SUBJECT: F400/F410 Dual Job Feeder separation belts
(manual correction)

FROM: Copier Technical Support Group

MODEL: F400/F410

Page 7 - upper illustration

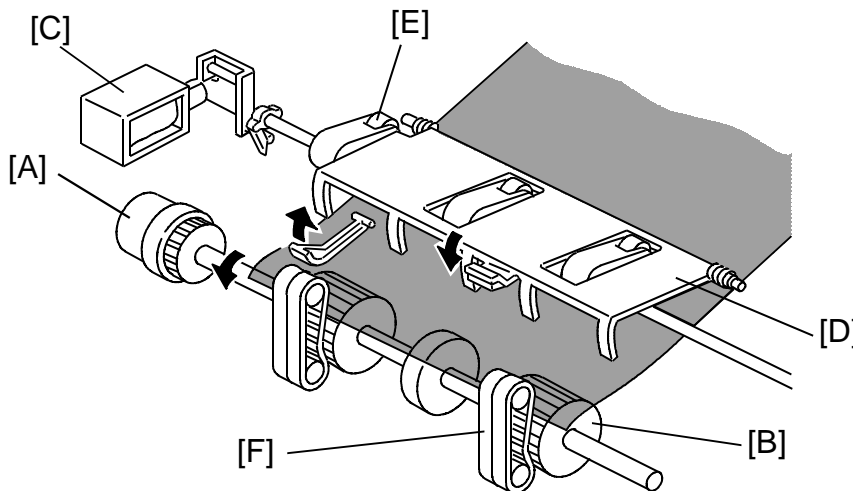
The quantity of the separation belt have been changed from two to four.

Because of this modification, the illustrations in page 7, 14, 15, 34 and 35 should be changed. The quantity of the separation belts should be doubled. There is no correction except illustrations.

Guide mylar ass'y : Part number A3761254

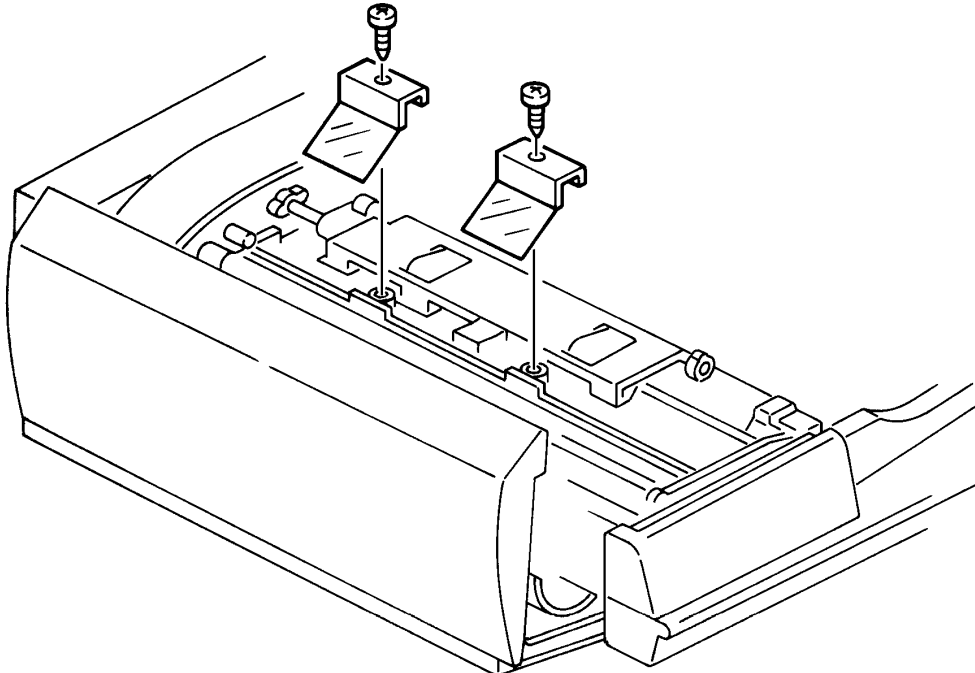
Original multiple feeding occurs when there is high friction between the originals. This tends to occur especially when the originals have staple holes, or computer forms with rough edges.

When the originals [A] comes between the feed rollers [B] and the separation belts [C], they meet the mylar [D] between them and the separation belts. This guide mylar transports the originals smoothly to the gap between the feed rollers and the separation belts. The mylar length determines the original separation force. If the mylar is longer, the area where the originals touch the separation belt becomes narrower, therefore the separation force become weaker. If the mylar is shorter, the separation force becomes stronger. (If it is too short, too much separation force stops original feed)
As a result of our investigation, we found that making the mylar 2mm shorter is the best condition (higher separation ability without feeding error).

Replace the original guide mylars (2 mylars per machine). New part is the assembled part of the mylar and the bracket. New part number is A3761254.

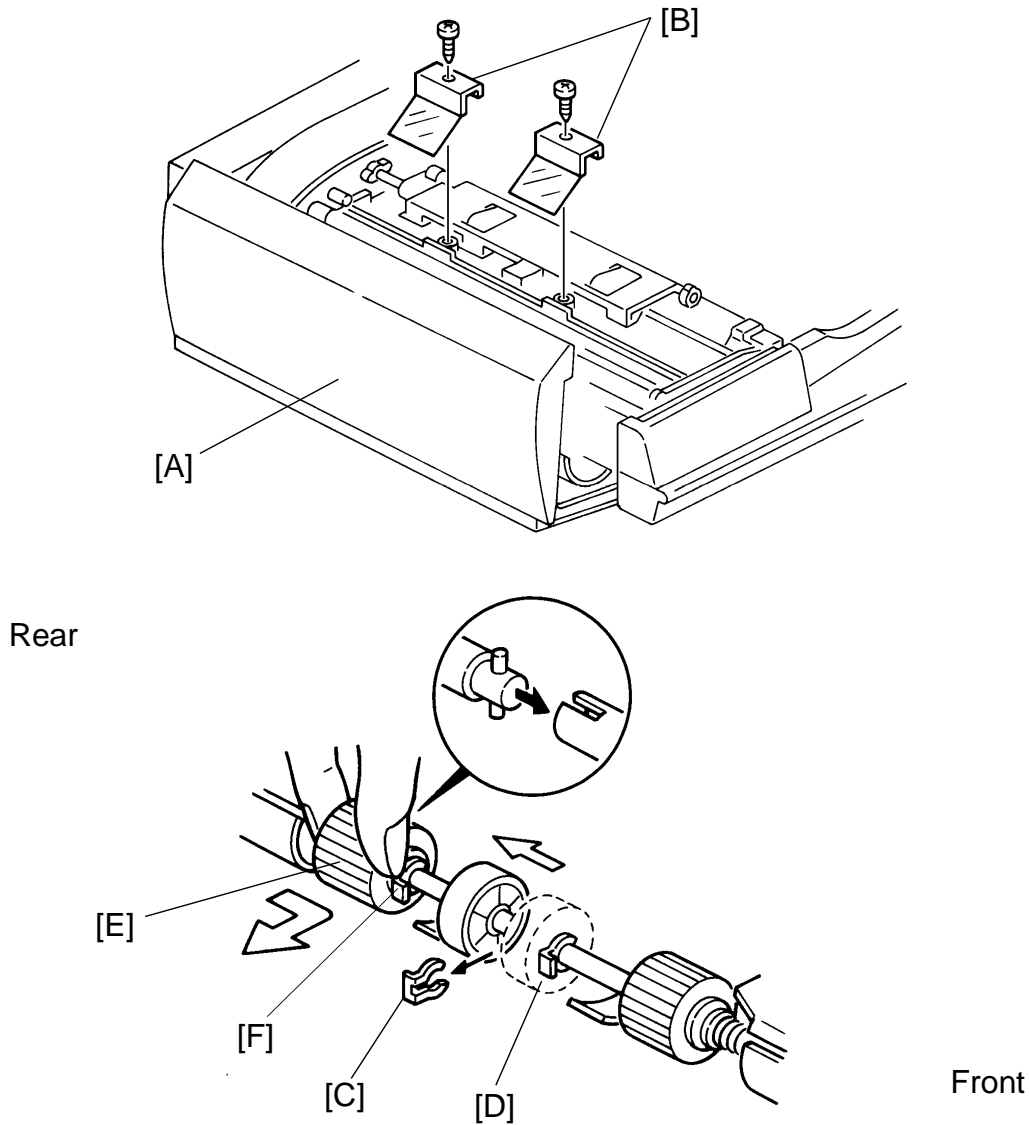
In the domestic market, we have experienced that the customer took off the feed roller assembly [A] when removing a jammed original. When the jammed original is pulled to the front, the feed rollers are pulled to the front and the joint part [B] comes out from the drive shaft. To prevent this, The middle roller [C] position has been changed (to the rear) as shown below.

Before the modification, the middle roller could be shifted to the front when the feed roller was pulled to the front. After the modification, when the feed roller is pulled to the front, the middle roller hits the guide plate and it cannot be moved to the front. This prevents the joint part from being separated by mistake.

To replace the feed roller assembly, the following procedure is necessary before performing step 6 (slide the feed roller assembly to the front, then remove it).

- * Remove the guide mylars
- * Remove the snap ring.
- * Hold the feed roller.

DJF/RDH feed motor defectiveDJF/RDH transport motor defectiveDJF/RDH feed out motor defectiveRDH inverter motor defective**Page 11 of DJF Illustration**

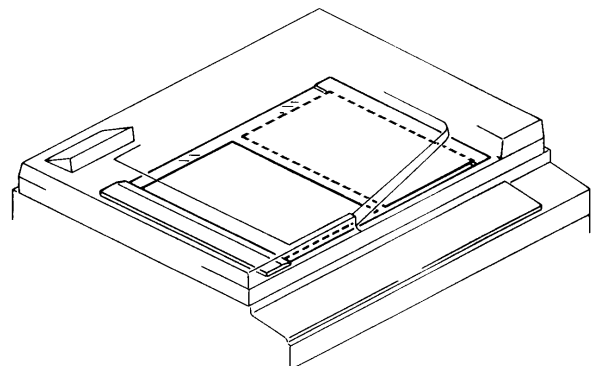
In Fig.2, the left paper is expressed by a dotted line and the right paper is expressed by solid line.

In Fig.2, the left paper position is shown by a solid line and the right paper position is shown by a dotted line as shown.

Page 27 of DJF 3rd line of upper NOTE and Illustration

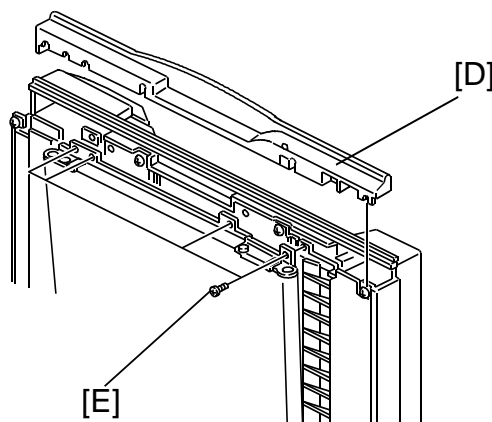
- Incorrect
..... loosen four truss head screws [D], and tighten.

- Correct
..... remove the cover [D] (4 screws), and loosen then tighten 4 screws [E].

Page 43 of DJF Illustration

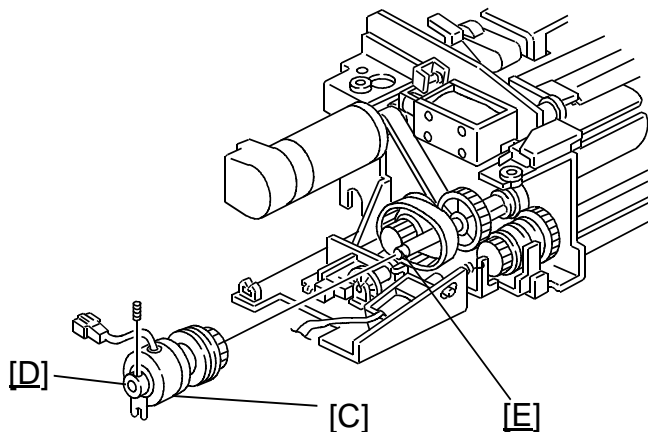
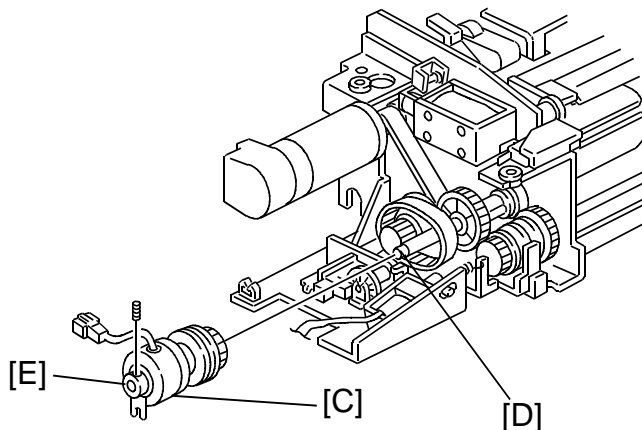
- Incorrect

- Correct

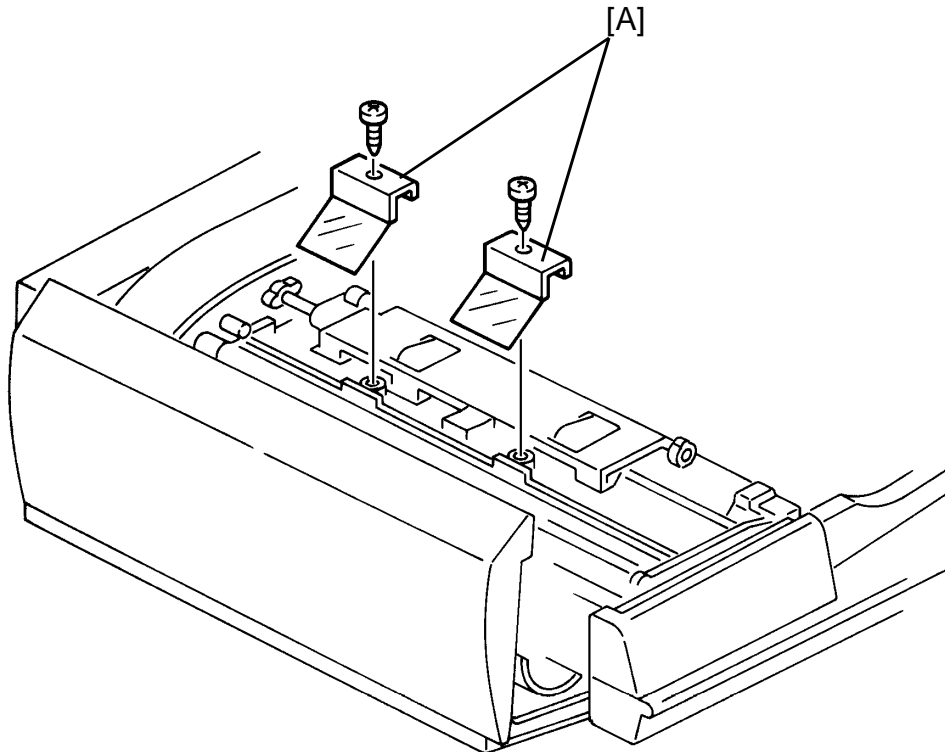
Note: If block original feeding (10~20 sheets of originals are fed at a time) occurs, replace the original guide mylars [A] to the new parts (A3761254). Please refer to RTB-008 for the details.

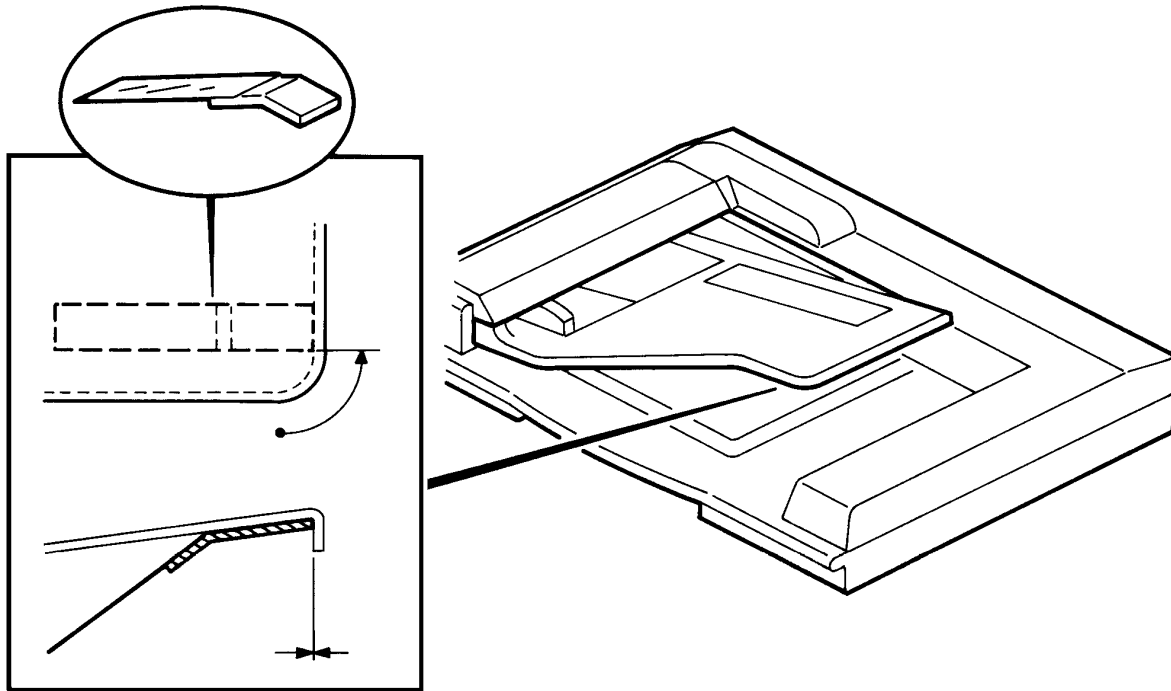
During auto counting mode, the original delivery speed varies. The original stack alignment become irregular, and in the worst case, the original order changes.

When the original is delivered in auto counting mode, the original exit motor changes its speed. Just before the trailing edge of the original passes through the exit roller, its speed decreases to correct the original stack. Normally the original exit motor changes to the quicker speed after completely feeding out the original. However, sometimes, the exit motor returns to the quicker speed before the original trailing edge passes through the exit roller. In this case, the original is pushed out quickly, resulting in the irregular original stack.

The original stack guide mylar is added. This mylar is attached to the DJF as an accessory. Please install the mylar at installation as shown in the illustration below.

Separation Belts

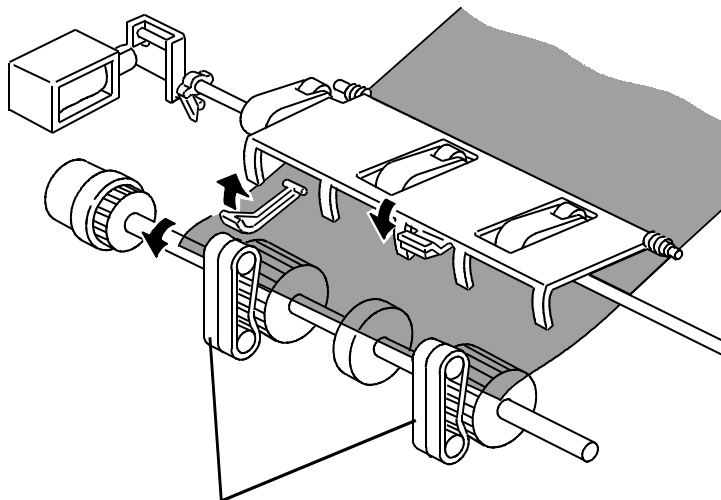
The separation belts become dirty with the toner, losing the friction to separate the originals.

This is especially true when the customer feeds lots of poorly fused originals such as laser output or cotton paper.

Replace the separation belts with the new parts. The new part number is A3769502.

The material of the separation belts has been changed to the one which less toner adheres to.

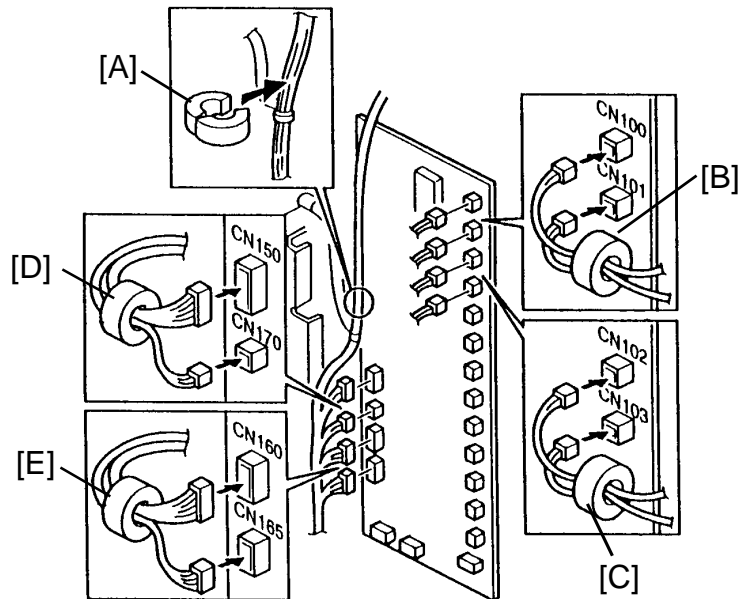
To comply with the CE mark, it is necessary to attach five ferrite cores when installing a sorter on DFC - α . The ferrite cores have been enclosed in the screw bag of the DFC - α from September production. Please refer to the following for the installation procedure of the ferrite cores.

1. Turn off the main switch and unplug the machine.
2. Remove the sorter top cover (3 screws).
3. Remove the sorter rear cover (4 screws).
4. Attach the ferrite core ([A] P/N 16070721) to the DC harness as shown.

5. Remove the harnesses for second bin solenoid (CN100) and third bin solenoid (CN101). Pass the both harnesses through the ferrite core ([B] P/N 16070418) and reconnect them to the sorter main board.
6. Remove the harnesses for the fourth bin solenoid (CN102) and the fifth bin solenoid (CN103). Pass the both harnesses through the ferrite core ([C] P/N 16070418) and reconnect them to the sorter main board.
7. Remove the harnesses for the encoder (CN150) and the entry sensor LED (CN170). Pass the both harnesses through the ferrite core ([D] P/N 16070418) and reconnect them to the sorter main board.
8. Remove the harnesses for the entry sensor Phototransistor (CN160) and the inlet sensor (CN165). Pass the both harnesses through the ferrite core ([E] P/N 16070418) and reconnect them to the sorter main board.
9. Reassemble the unit.
